Section 16 Planning Application for Proposed Minor Relaxation of Plot Ratio Restriction for Permitted Flat Use (Proposed Amendments to an Approved Scheme with Minor Relaxation of Plot Ratio Restriction under Application No. A/H6/91) at 4, 4A, 4B and 4C Tai Hang Road, Hong Kong (Application No. A/H6/97)

Responses to Departmental Comments

Annex A

Planning and Design Merits of the Proposed Scheme as Compared with the Approved Scheme (Application No. A/H6/91)

Checked	DH	Drawn	PW
Rev	0	Date	Jul 2026
Scale		Figure	A1

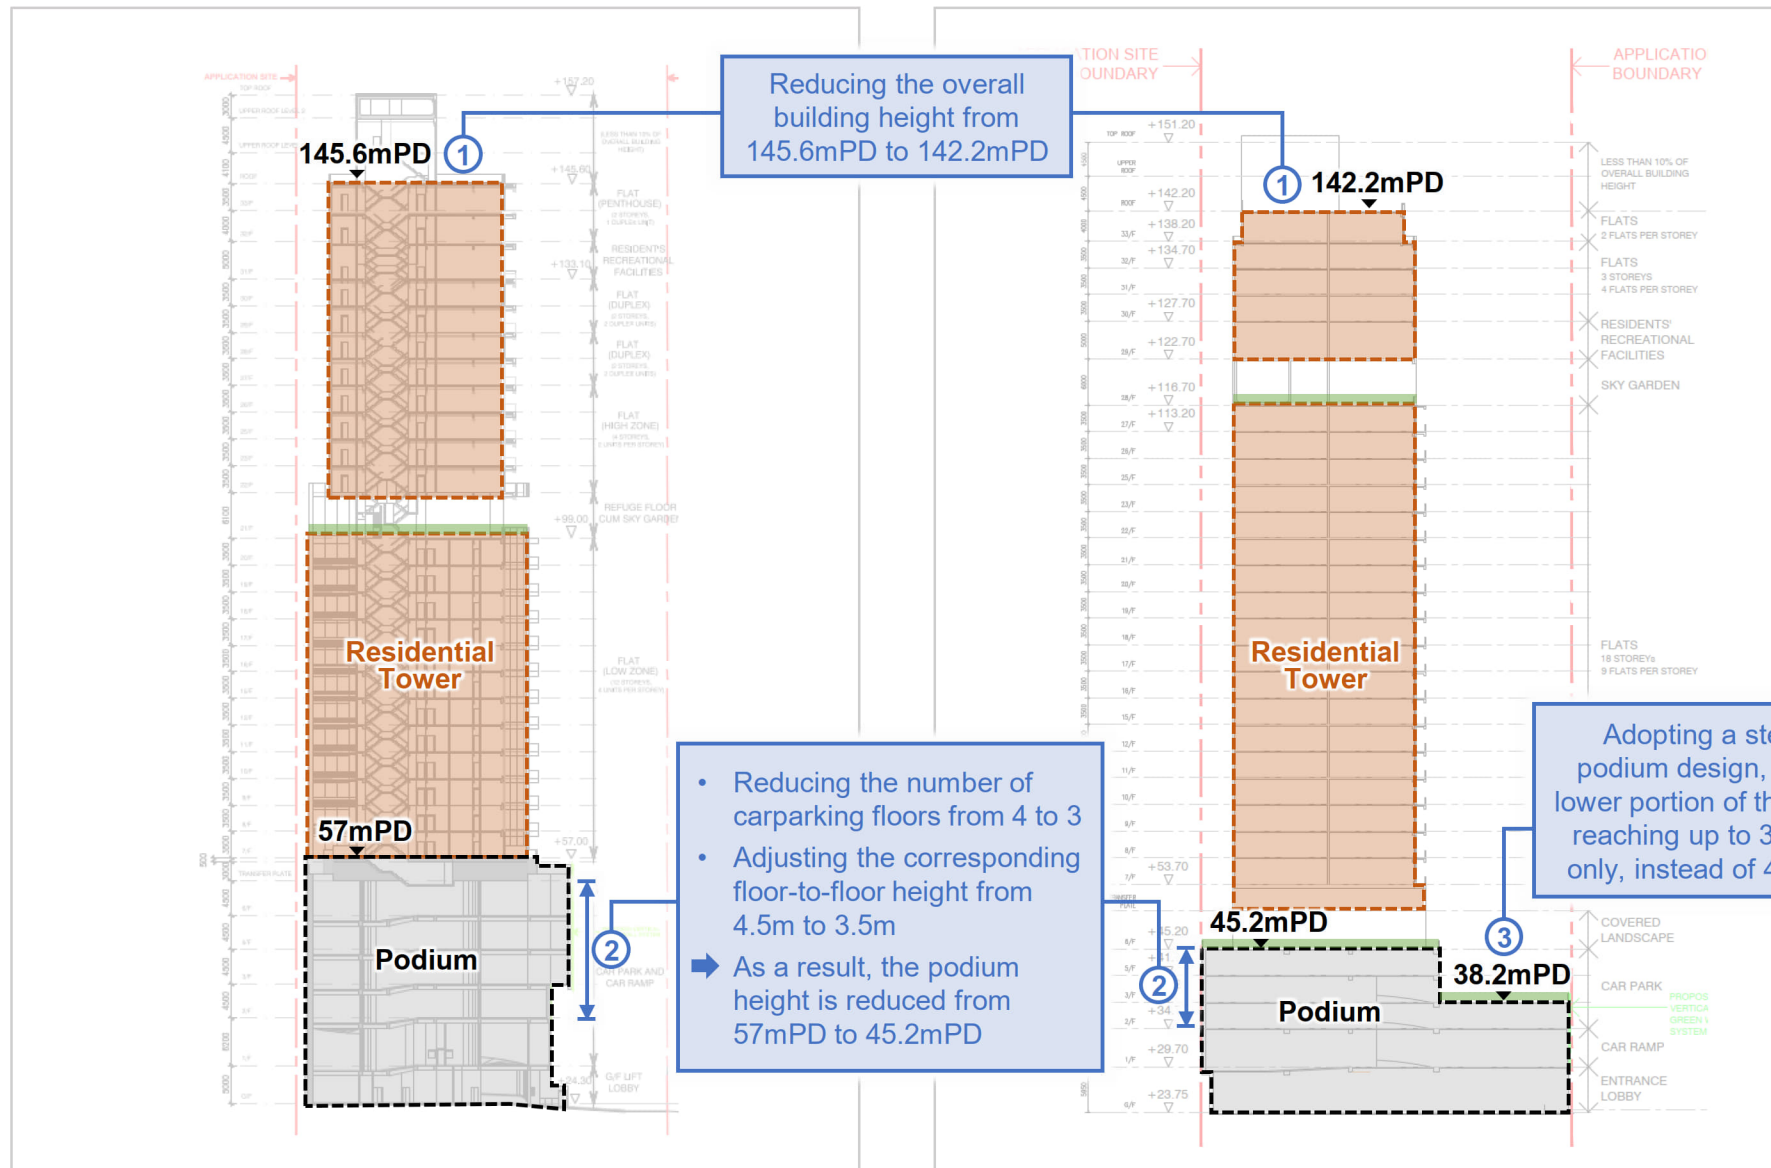
Item		Approved Scheme (Application No. A/H6/91)	Proposed Scheme
1	Overall Building Height (Figure A1)	The Approved Scheme complied with the OZP BH restriction of 30 storeys, with the main roof reaching 145.6mPD.	- In addition to complying with the OZP BH restriction of 30 storeys, the Applicant has proactively reduced the BH of the proposed development from 145.6mPD to 142.2mPD; - With a reduced BH as compared with the Approved Scheme, the proposed development will unlikely result in any additional visual or air ventilation impacts, and will ensure its visual compatibility with the surroundings.
2	Podium Height (Figure A1)	The podium has a height of 57mPD, comprising 4 carparking floors with floor-to-floor (FtF) height of 4.5m.	The Applicant has proactively optimized the podium design by reducing the number of carparking floors from 4 to 3, and adjusting the corresponding FtF height from 4.5m to 3.5m, thereby lowering the podium height to 45.2mPD. This represents a significant reduction of 11.8m (about 21%), which helps minimize the podium bulk, enhance the pedestrian streetscape and effectively mitigate its visual impact.

3	Stepped Podium Design (Figure A1)	N/A	The Proposed Scheme adopts a stepped podium design, with the lower portion of the podium reaching up to 38.2mPD only, instead of 45.2mPD, to break down the podium massing.
4	Breaking Down Development Bulk (Figure A2)	The residential tower extends directly upwards from the podium, creating a continuous and massive development bulk.	A covered landscape area is introduced on 6/F to create a separation between the podium and the residential tower atop, breaking down the development bulk.
5	Allowing Cross-Ventilation (Figure A2)	A sky garden is provided on 21/F to allow cross-ventilation through the development.	In addition to the sky garden on 28/F, a new covered landscape area is also provided on 6/F, which will further allow cross-ventilation through the development.

Checked	DH	Drawn	PW
Rev	0	Date	Jul 2026
Scale		Figure	A2

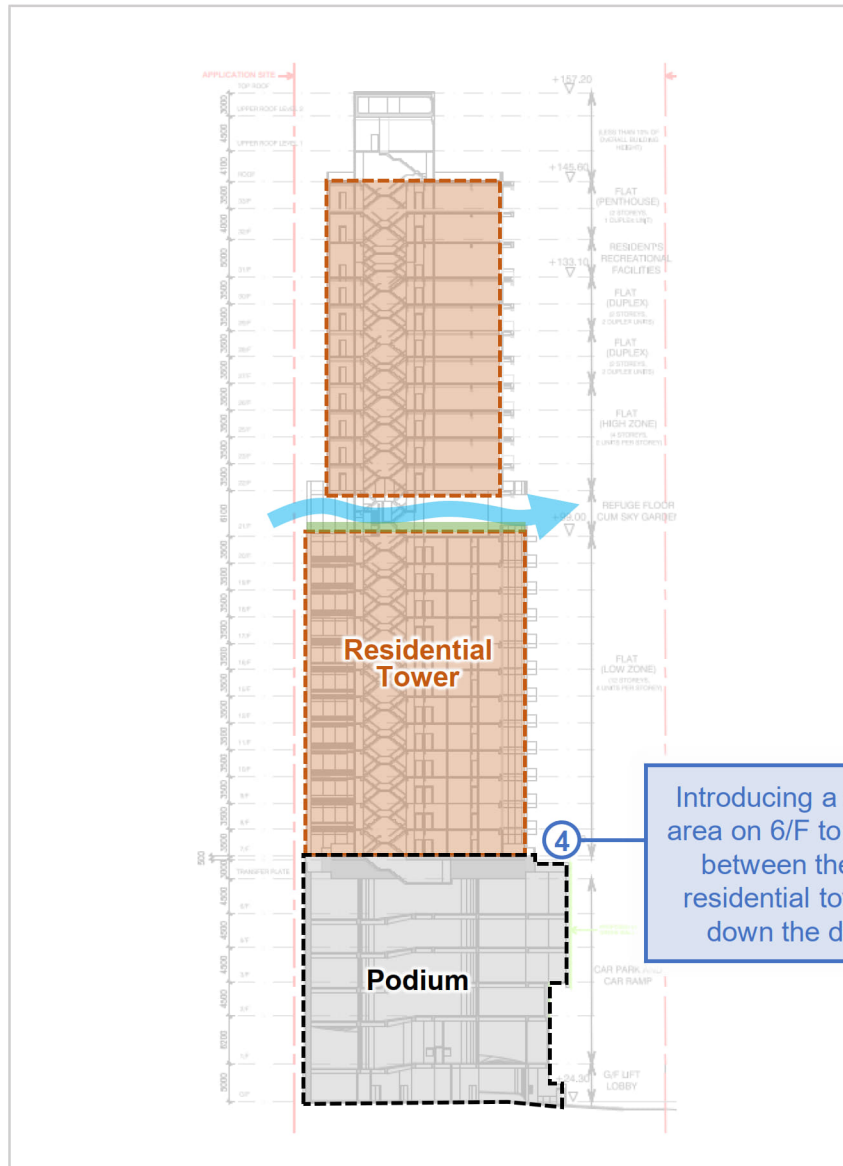
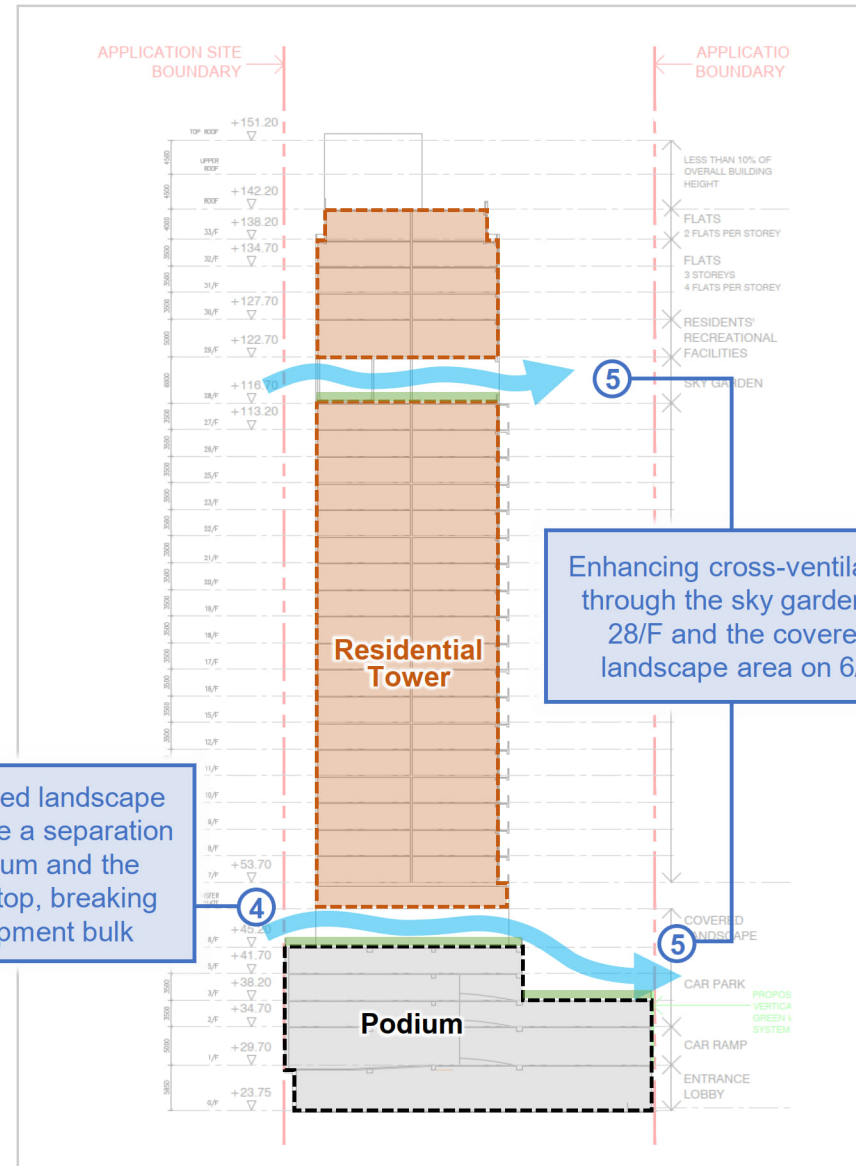
Enhancing cross-ventilation through the sky garden at 28/F and the covered landscape area on 6/F

Introducing a covered landscape area on 6/F to create a separation between the podium and the residential tower atop, breaking down the development bulk

Checked	DH	Drawn	PW
Rev	0	Date	Jul 2026
Scale		Figure	A3

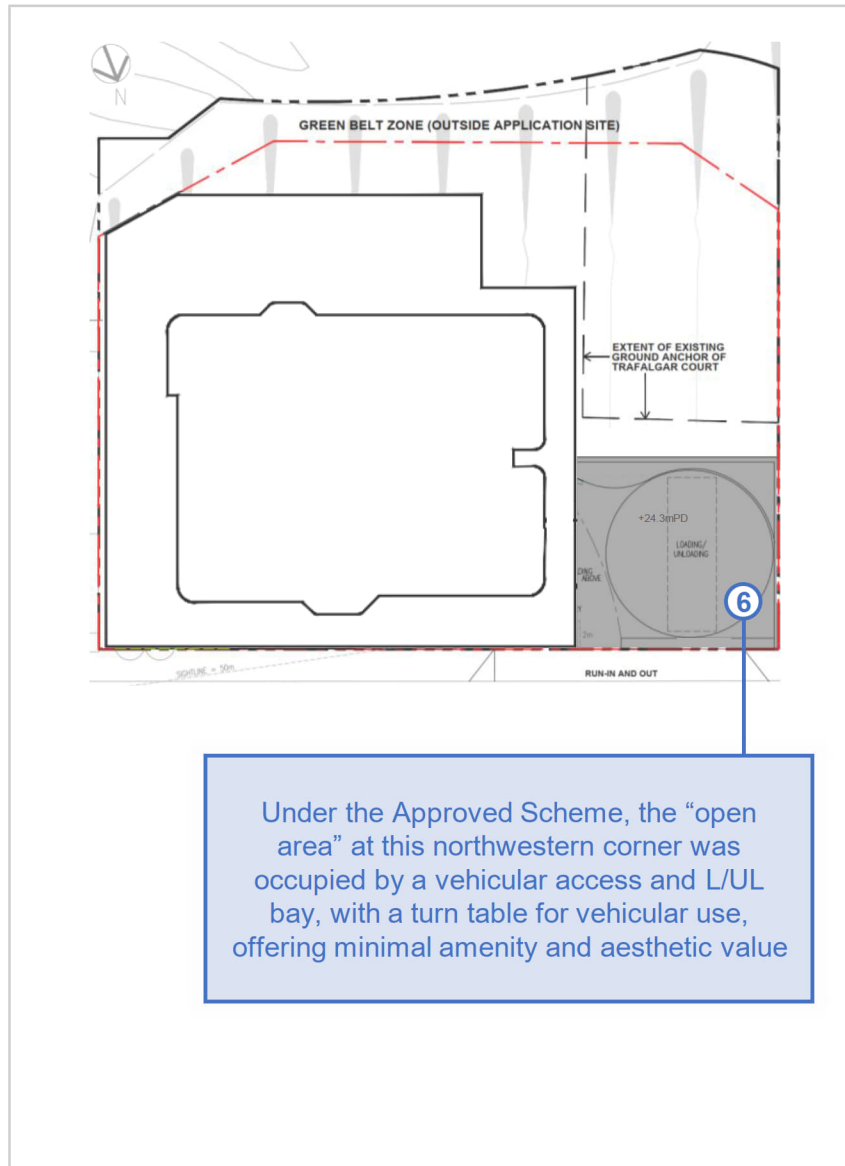
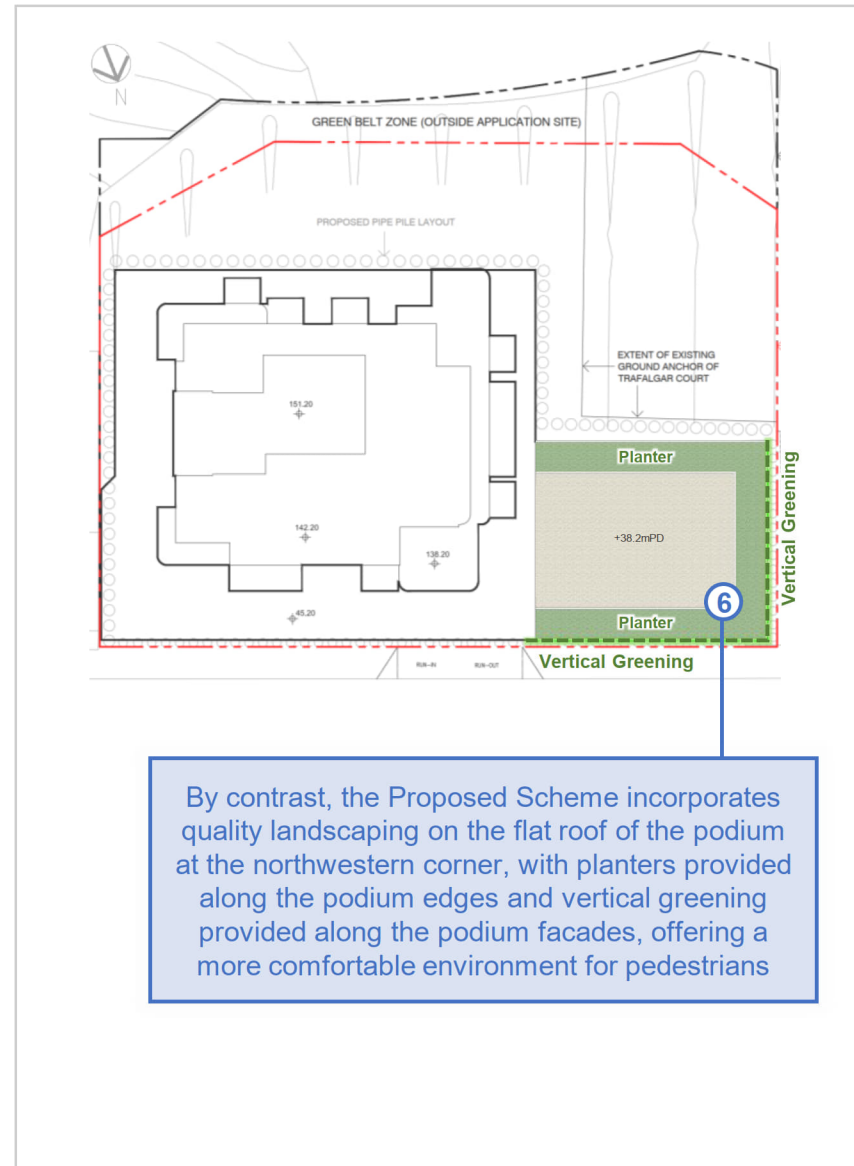
Item		Approved Scheme (Application No. A/H6/91)	Proposed Scheme
6	Podium Extent (Figure A3)	Under the Approved Scheme, although the podium footprint did not extend to the northwestern corner of the site, the “open area” at the northwestern corner of the site was not for private open space use, but was occupied by a vehicular access and loading/unloading bay, with a turn table for vehicular use, offering minimal amenity and aesthetic value.	- By contrast, under the Proposed Scheme, the Applicant has reduced the podium height from 57mPD to 45.2mPD (as discussed in Item 2 above). After reducing the podium height significantly, the podium length has to be extended along the frontage of Tai Hang Road inevitably to accommodate the necessary parking and E&M facilities. Yet, effort has been made to minimize the height of the extended portion of the podium as far as practicable. Compared with the height of the main portion of the podium at 45.2mPD, the height of the extended portion of the podium is minimized to 38.2mPD only, facilitating air ventilation above. - To further mitigate its bulk, quality landscaping is incorporated on the flat roof of the podium, with planters provided along the podium edges in the northern (facing Tai Hang Road), western and southern sides to enhance the landscape and amenity. Vertical greening is also provided along the podium façades in the northern (facing Tai Hang Road) and western sides, which helps shield the retaining slope structure at the back to provide effective visual relief. This offers a more comfortable environment for pedestrians compared to the vehicular access, L/UL bay and turn table in the Approved Scheme.

Under the Approved Scheme, the “open area” at this northwestern corner was occupied by a vehicular access and L/UL bay, with a turn table for vehicular use, offering minimal amenity and aesthetic value

By contrast, the Proposed Scheme incorporates quality landscaping on the flat roof of the podium at the northwestern corner, with planters provided along the podium edges and vertical greening provided along the podium facades, offering a more comfortable environment for pedestrians

Checked	DH	Drawn	PW
Rev	0	Date	Jul 2026
Scale	Figure A4

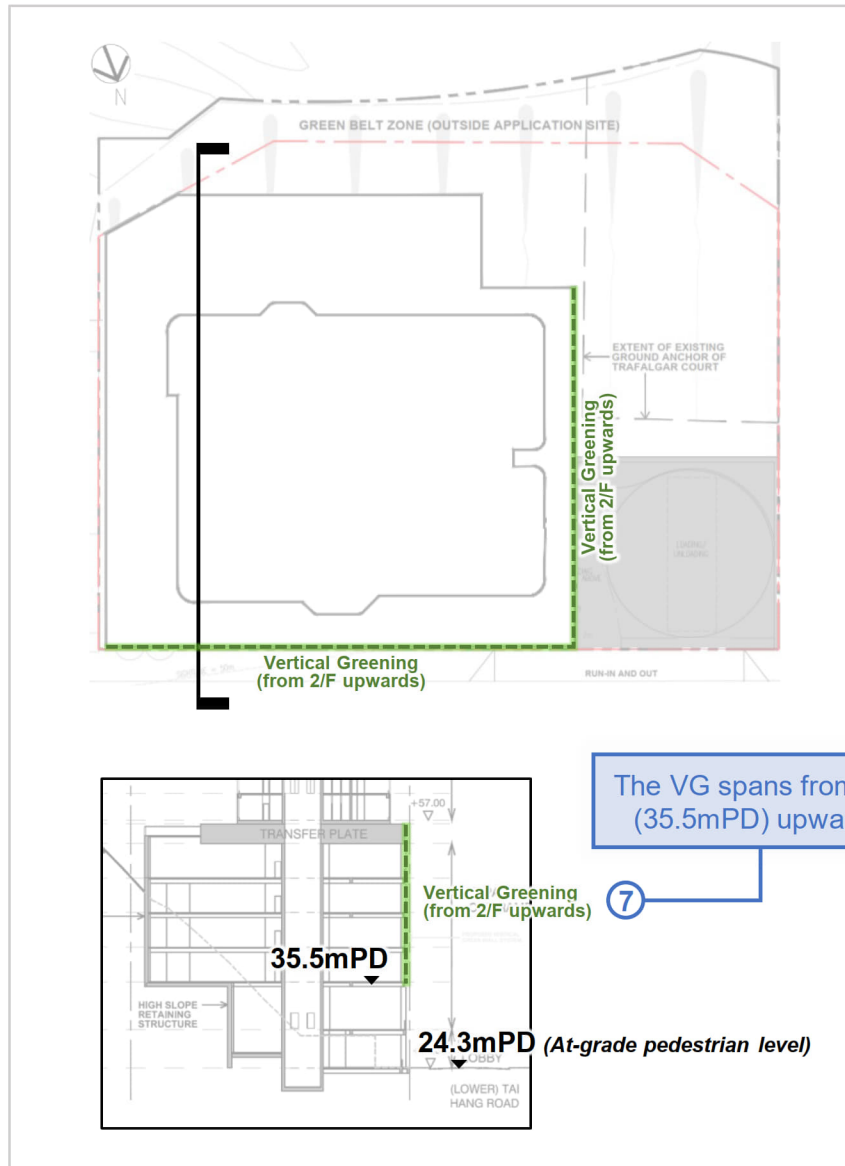
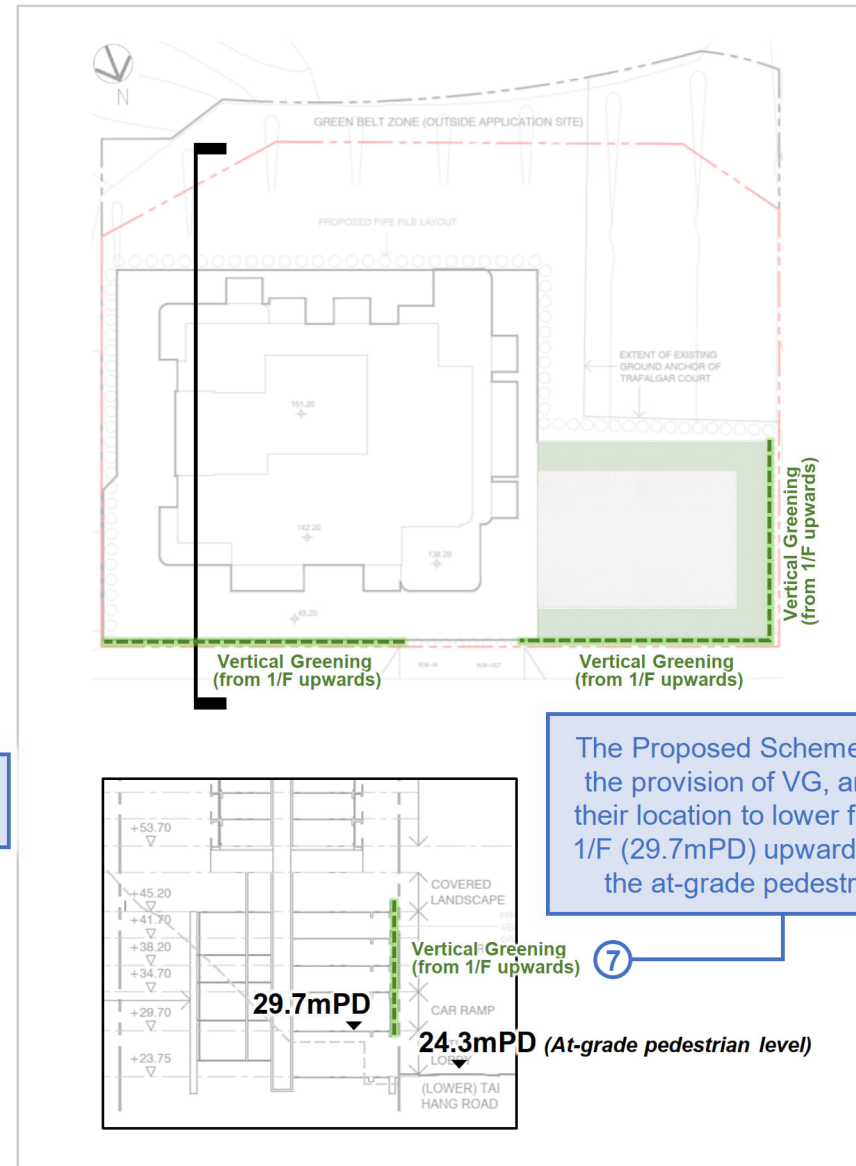
7	Vertical Greening (Figure A4)	Vertical greening is provided along the podium façades in the northern (facing Tai Hang Road) and western sides to serve as visual relief and enhance the street environment.	- Same as the Approved Scheme, vertical greening is provided along the podium façades in the northern (facing Tai Hang Road) and western sides to serve as visual relief and enhance the street environment; - In addition to maintaining the provision of vertical greening, the Proposed Scheme also adjusted the location of vertical greening to lower floors closer to the at-grade pedestrian level. This ensures that pedestrians passing by can experience a more pleasant and immediate green environment.

The VG spans from 2/F (35.5mPD) upwards

The Proposed Scheme maintains the provision of VG, and adjusts their location to lower floors (from 1/F (29.7mPD) upwards) closer to the at-grade pedestrian level
